**Pacific Gas and  
Electric Company®**

PG&E Letter DCL-09-065

Docket No. 50-275, OL-DPR-80  
Docket No. 50-323, OL-DPR-82  
Diablo Canyon Units 1 and 2  
Response to NRC Request for Additional Information Regarding Emergency  
License Amendment Request 09-04, "Revision to Technical Specification 3.7.1,  
'Main Steam Safety Valves (MSSVs) for Unit 2 Cycle 15'"

**PG&E Response to NRC Request for Additional Information Regarding  
Emergency License Amendment Request 09-04, "Revision to Technical  
Specification 3.7.1, 'Main Steam Safety Valves (MSSVs) for Unit 2 Cycle 15'"**

**Figure 1**

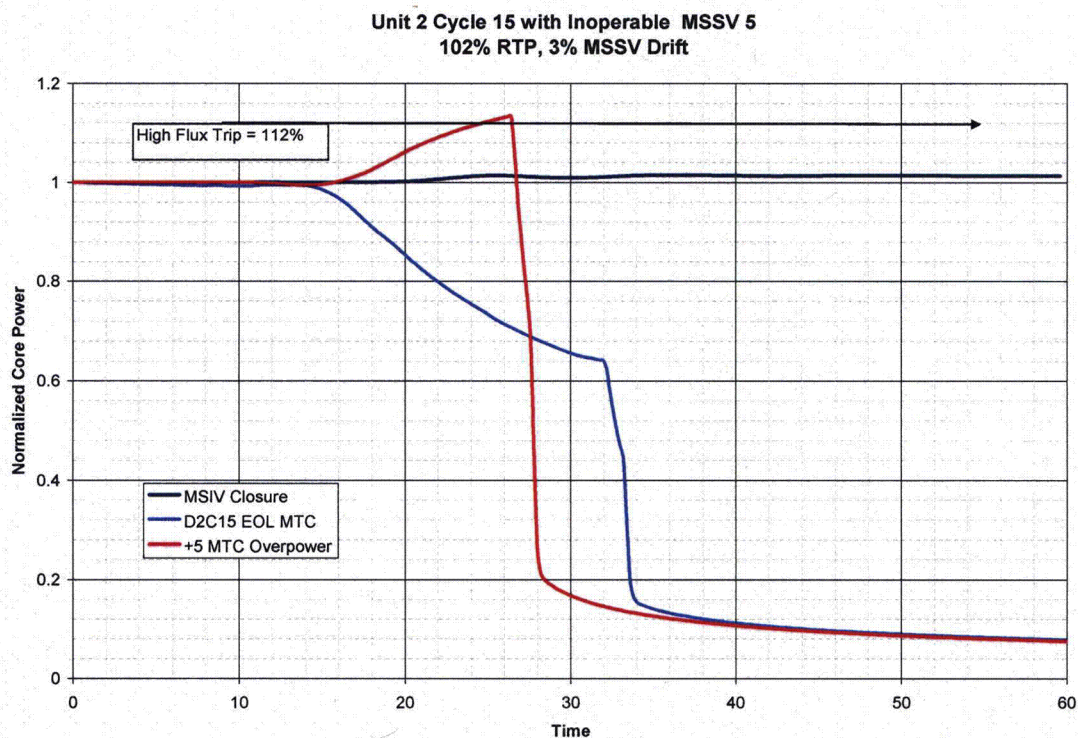
*In the NRC staff's judgment, the integral power achieved during the pre-trip power ascension could be a fairly significant factor affecting the secondary pressure rise. Therefore, the assertion that initiating the transient at 102-percent power is a conservative treatment of power uncertainty may not be correct.*

*Discuss why initiating the loss of load/turbine trip (LOL/TT) transient in an overpower condition is conservative relative to secondary pressurization when the transient is assumed to be terminated by an overpower trip. Address (1) whether initiating the transient from a 98-percent power condition would result in a greater secondary pressurization, and (2) why the modeling technique employed is sufficiently conservative to account for this potentially greater pressurization.*

In PG&E Letter DCL-09-062, "Emergency License Amendment Request (LAR) 09-04, Revision to Technical Specification 3.7.1, 'Main Steam Safety Valves (MSSVs) for Unit 2 Cycle 15,'" dated September 3, 2009, the three separate RETRAN cases analyzed at full power conditions conservatively bound the maximum potential challenge to the main steam safety valve (MSSV) relief capacity for any credible event that could occur during the remainder of DCPP Unit 2 Cycle 15 operation.

RETRAN Case 1 assumed a noncredible +5 percent milli-rho per degree Fahrenheit (pcm/°F) Moderator Temperature Coefficient (MTC) to bound any potential power increase transient that could occur since a LOL event and subsequent reactor coolant system (RCS) heatup can not result in a power increase with the current Unit 2 Cycle 15 core conditions (see the RETRAN Case 2 discussion on MTC below). Any power increase transient that could occur such as an excessive load increase is not limiting for secondary pressurization since it would not result in a turbine trip and stop secondary heat removal until a reactor trip is generated. Any power increase transient that could occur at a lower power level would continue to have secondary heat removal until it eventually reached the same Power Range Neutron Flux High setpoint as analyzed in RETRAN Case 1, unless another reactor trip such as the Overtemperature Delta Temperature trip occurred earlier. Analyzing the overpower transient from 102 percent rated thermal power (RTP) combined with an assumed instantaneous loss of secondary heat removal capability and a nuclear power increase up to the 112 percent high flux trip setpoint conservatively maximizes the core decay heat and energy transferred into the RCS at the time the high flux trip occurs. Therefore, RETRAN Case 1 conservatively determines the reduction in the high flux trip setpoint that must be implemented to ensure the core power and integral energy transferred into the RCS at the time of reactor trip do not exceed the MSSV relief capacity for any credible overpower transient that could occur during the remainder of Unit 2 Cycle 15.

RETRAN Case 2 is analyzed at 102 percent RTP with a negative MTC that bounds the Unit 2 Cycle 15 conditions to demonstrate that any LOL event can not transfer enough energy into the RCS to exceed the operable MSSV relief capacity. The full-power Unit 2 Cycle 15 RCS boron concentration is currently less than 300 parts per million (ppm), and at any power level and associated RCS  $T_{avg}$ , the MTC will be very negative. Figure 1 shows the power level versus time for the RETRAN cases analyzed. With the negative MTC, the core power is significantly reduced due to the negative reactivity feedback as the RCS heats up following the LOL and associated loss of secondary heat removal. The MSSVs open before the reactor trip occurs and the net sudden increase in secondary heat removal combined with the rapid reduction in core power level result in a reactor trip on low pressurizer pressure. With a negative end of life (EOL) MTC, any LOL transient that is initiated from less than full power will still result in a rapid power reduction and will depressurize faster to the reactor trip setpoint when the MSSVs open. Therefore, it is not credible that a LOL event, which initiates at a power level lower than 102 percent RTP when combined with the Unit 2 Cycle 15 EOL MTC analyzed, could transfer more integral energy into the RCS prior to the reactor trip. The RETRAN Case 2 analyzed at 102 percent RTP and with the near EOL MTC is bounding for any LOL event that could occur at a reduced power level for the remainder of Unit 2 Cycle 15 operation.

RETRAN Case 3 analyzed an instantaneous closure of the main steam isolation valve (MSIV) and secondary steam flow on the affected steam generator (SG) at 102 percent RTP. This represents the maximum relief capacity challenge to the affected SG MSSVs that could occur for any steam flow transient that does not

result in a reactor trip. RETRAN Case 3 did not credit any control system or protection system interaction such that a reactor trip was precluded and the affected SG MSSVs were challenged to maintain steady state full power steam flow conditions without exceeding the secondary pressure limit. Any MSIV closure event that occurs at a lower power level would result in a reduced heat transfer challenge to the affected SG MSSVs and would be less limiting for evaluating the peak secondary pressurization.

RETRAN Cases 1, 2, and 3 were all evaluated using the same RETRAN thermal hydraulic model that is currently used for the LOL peak pressure analysis in Final Safety Analysis Report Section 15.2.7. As such, using this RETRAN model for the thermal hydraulic evaluation of the initial power conditions and instantaneous secondary heat removal is appropriately conservative for bounding the remainder of Unit 2 Cycle 15 for any secondary pressure increase transient that could occur.
